Thickener Area Mini-HAZOP Report

H354600-3310-142-066-0001

A Mini Hazard and Operability Study (HAZOP) Study was conducted for the thickener area for Project Lucy 2.0 Phase 1 on 10 September 2020. The HAZOP record is provided in Appendix C.

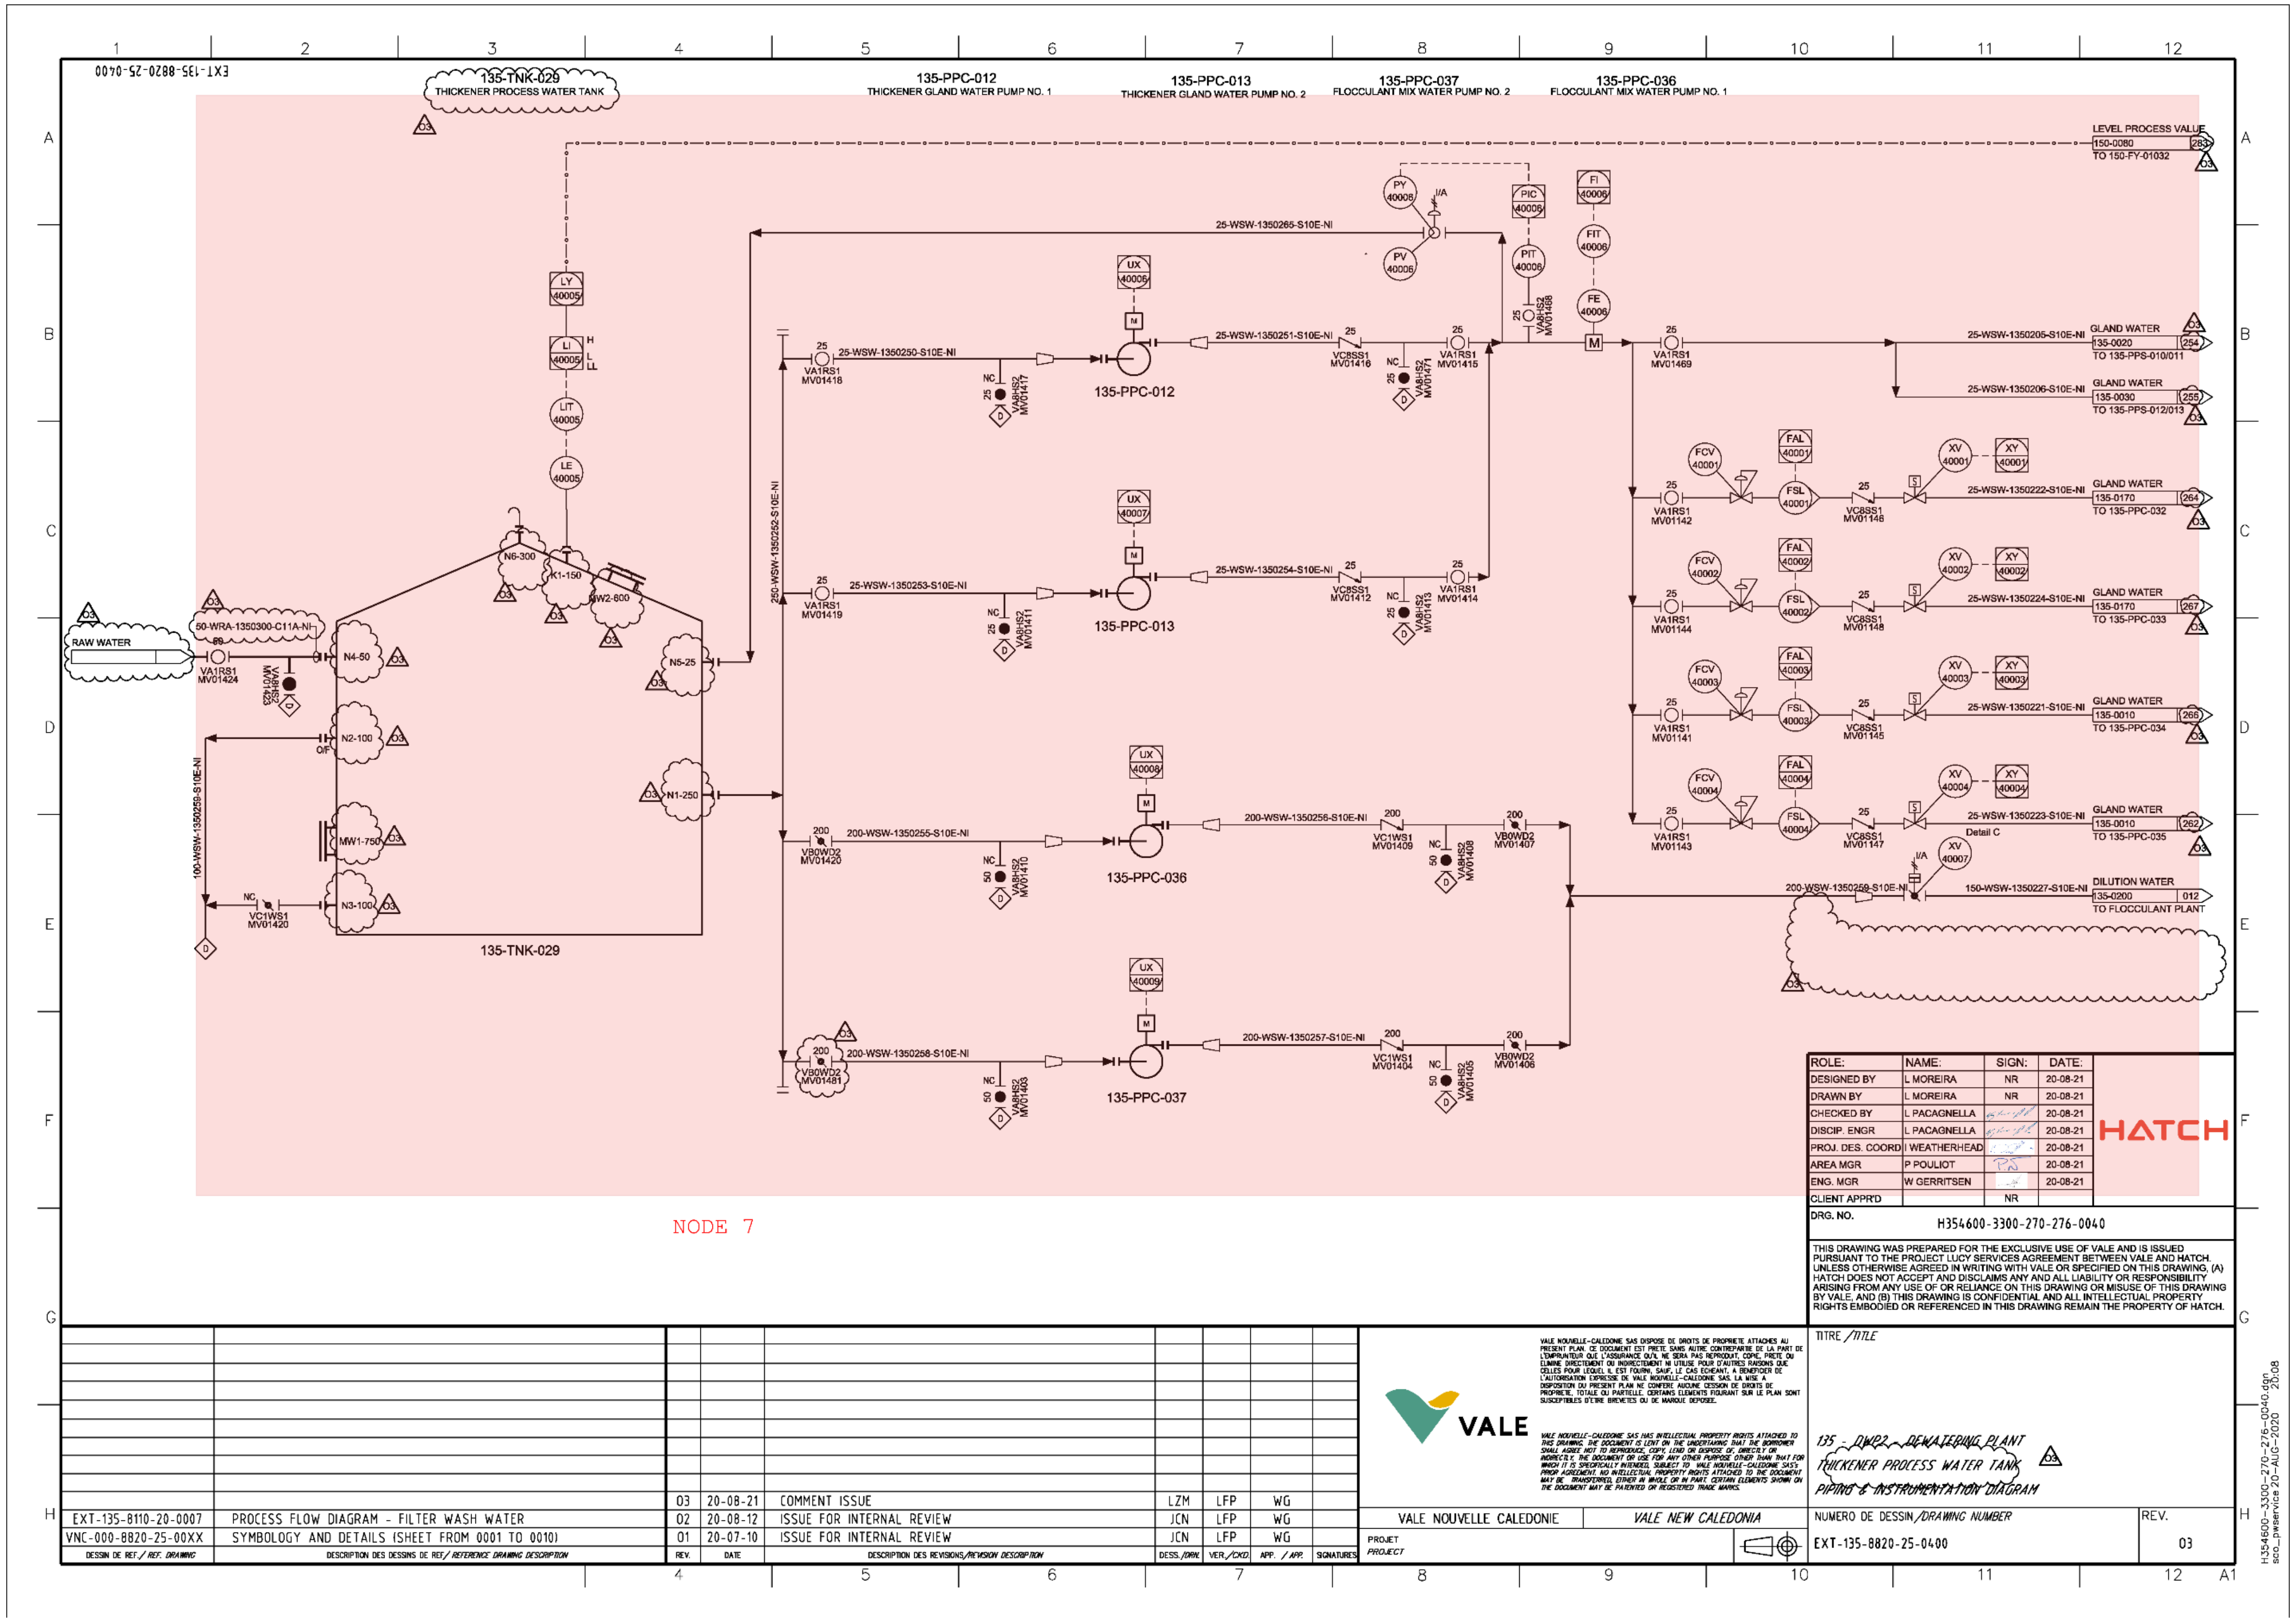
Node	Deviation	Cause	Consequence	Effective Safeguards	Recommendations	Responsibility
7. Thickener process water tank	1. High Flow – High Level	1. Failure to control incoming water	1. Overflow	1. Overflows to concrete pad, then to bund

2. Gland water pumps over pumping	1. No problems identified.	1. Recirculation line	20. Ensure pump 36/37 start is interlocked to control valve.	Mateus

2. Control pressure & flow for gland water		
				3. Single duty pumps for flocculant dilution water.		
	2. Low Flow - Low Level	1. Suction valve closed, pump has no water.	1. Burn mechanical seal	1. Gland water flow switches will protect pumps.	21. Add flow switch on common discharge to protect pump.	Mateus

7. Low Temperature					
	8. Process Control					
	9. Contamination	1. Algae in tank	1. Block pumps		22. Add spool for basket strainer at suction of pumps 012, 013.	Brett

PIPING & INSTRUMENTATION DIAGRAM
EXT-135-8820-25-0410
REV. 03

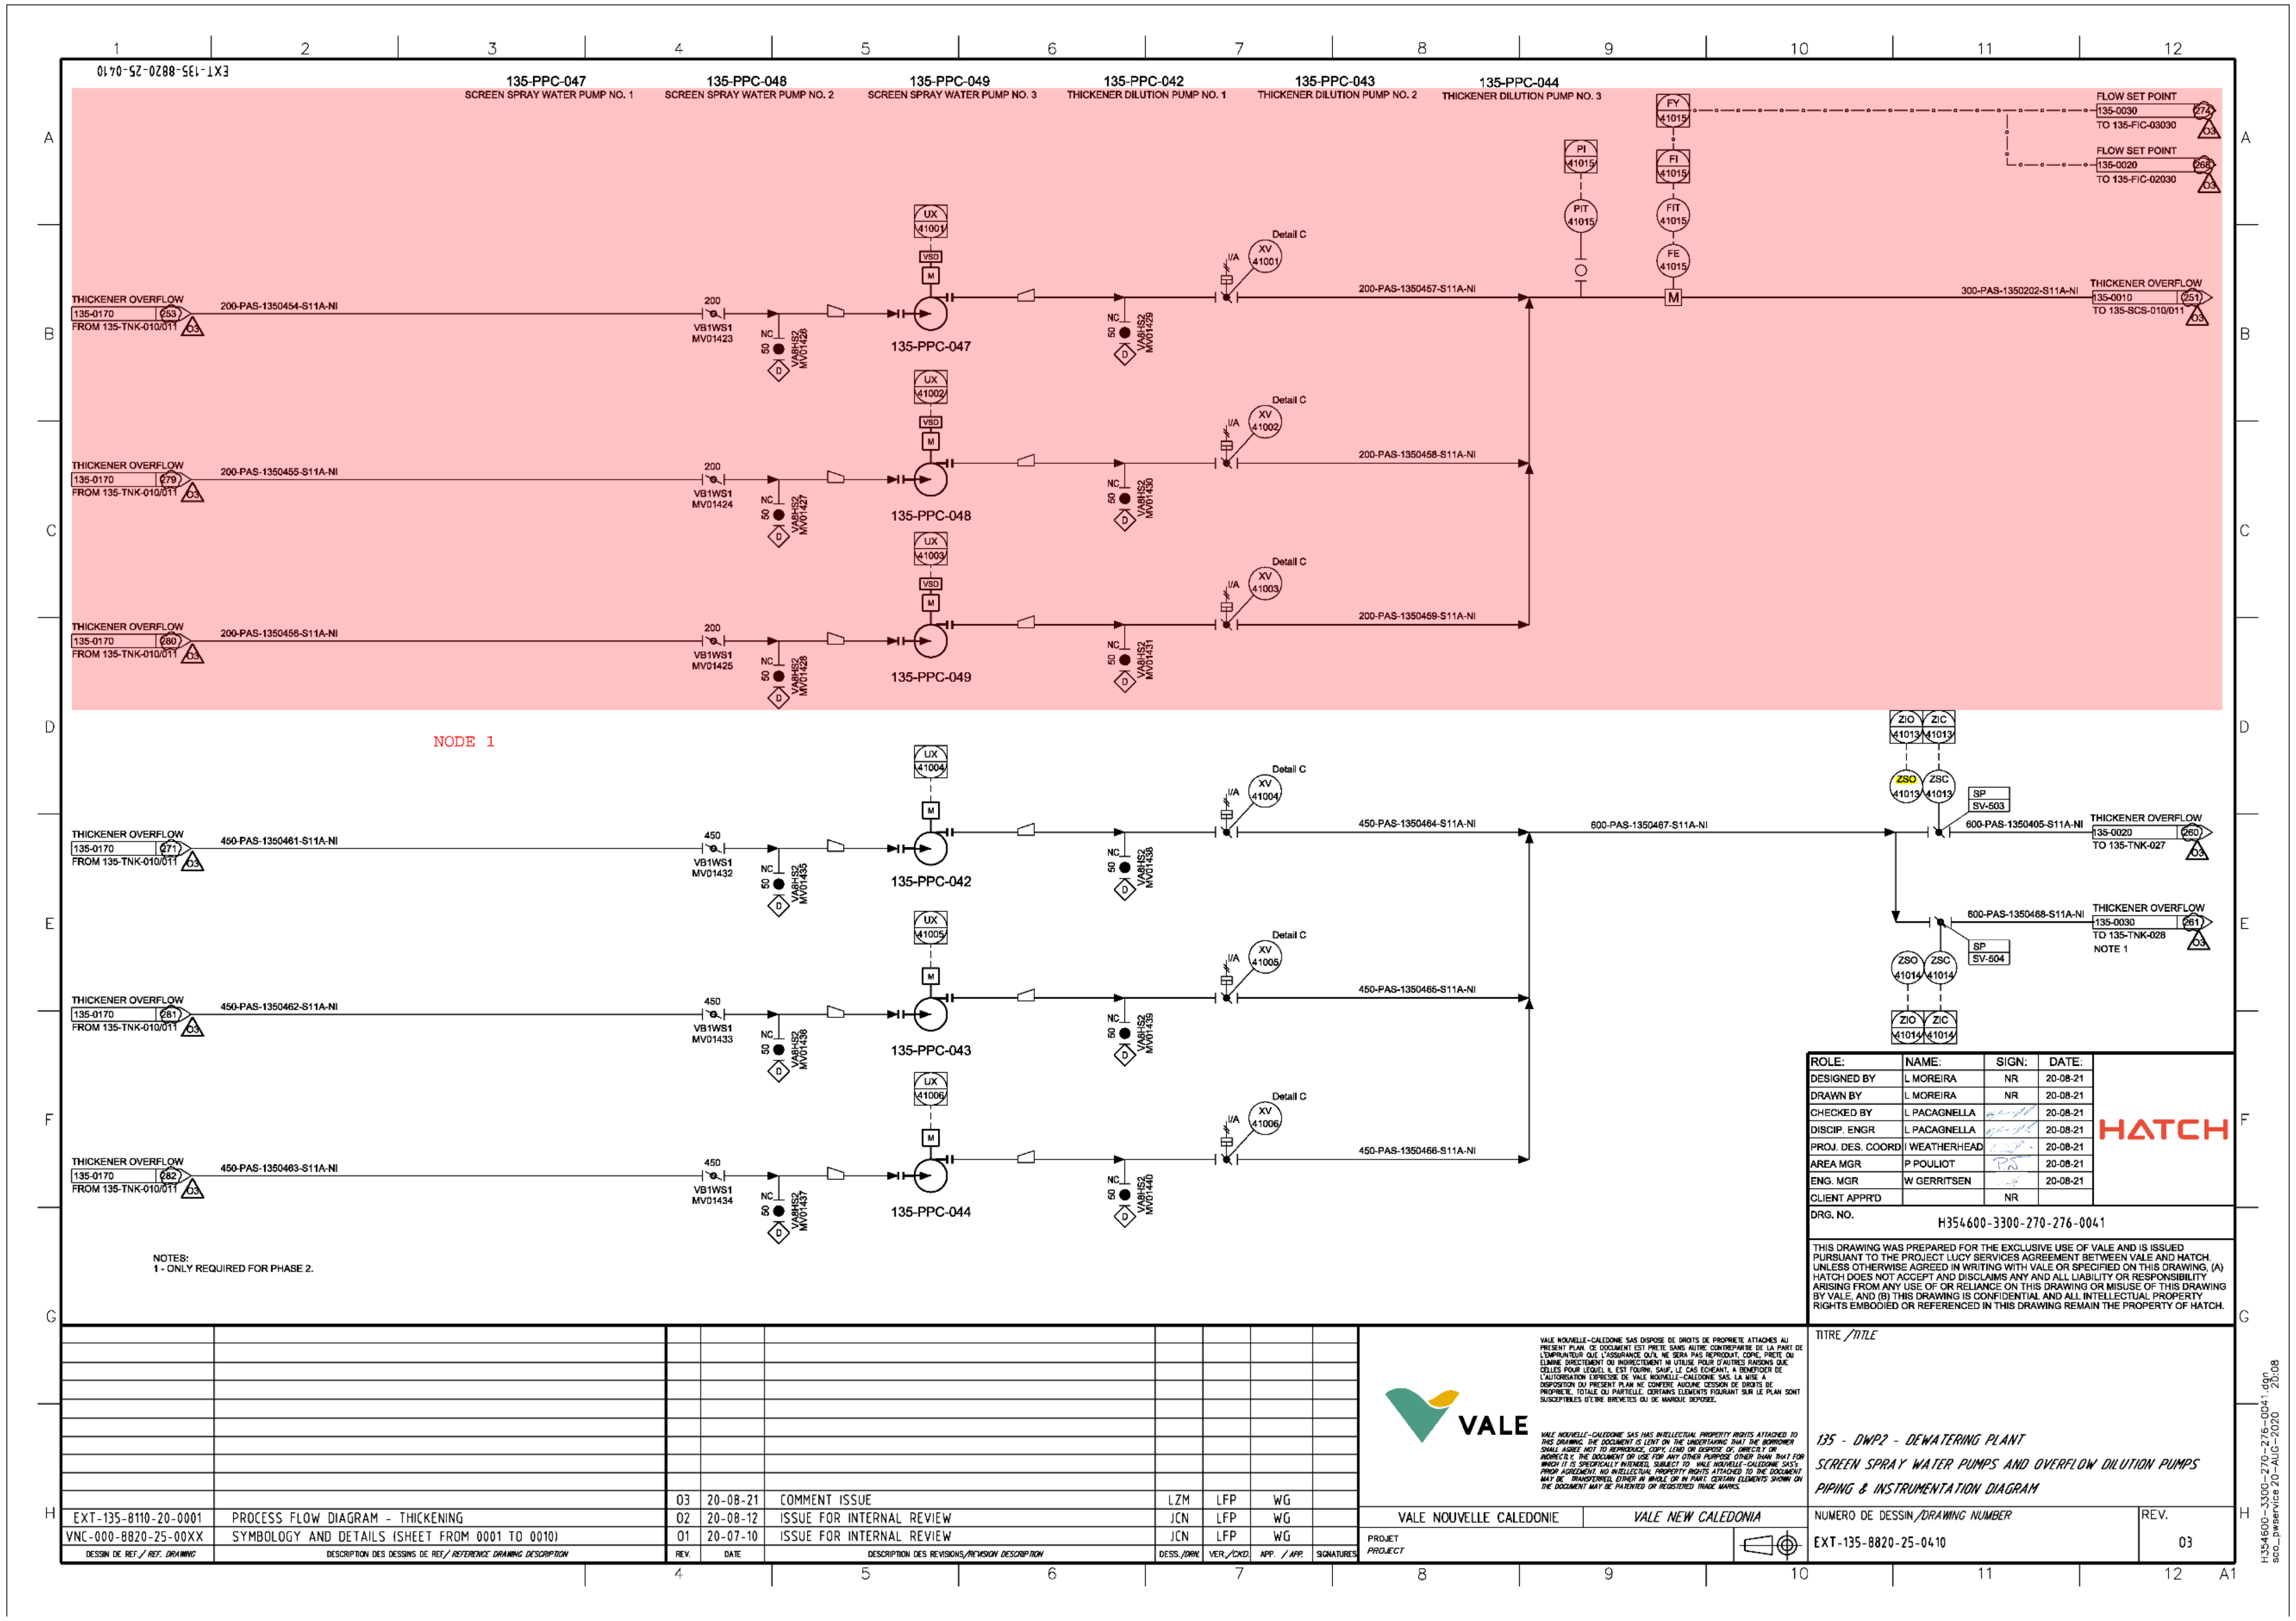
Node	Deviation	Cause	Consequence	Effective Safeguards	Recommendations	Responsibility
1. Thickener overflow to screen spray wash	1. High Flow – High Level	1. 3 pumps running instead of 2	1. Excess fluid to screens, extra dilution		1. Ensure appropriate pump control in place.	Flore

2. Low Flow - Low Level	1. Not enough water	1. Blocked screen, possible overflow	1. Low flow switch/alarm	2. Calculate condition-based maintenance for sprinklers. Baseline pressure/flow characteristics during commissioning and look for anomalies during operation.	Flore

2. Damage to pumps	2. flow meter after pumps	3. Check whether screen overflow will be directed to bund or bin.	Brett
				3. Pressure transmitter after pumps	4. Consider whether limit switches are required on manual valves to interlock pump start.	Brett

4. Pump current measurement & control, tank level above NPSH requirement.	5. Confirm pump stops on insufficient flow after 30 seconds.	Mateus
				5. CCTV

2. Problem with pumps				
		3. Closed suction valve (manual) (similar to not enough water)				
		4. Sprinklers blocked from solids contamination				
	3. Reverse Flow	1. Liquid will flow backwards if pumps stop.	1. Damage to pump	1. NRV has been marked up on discharge of each pump.
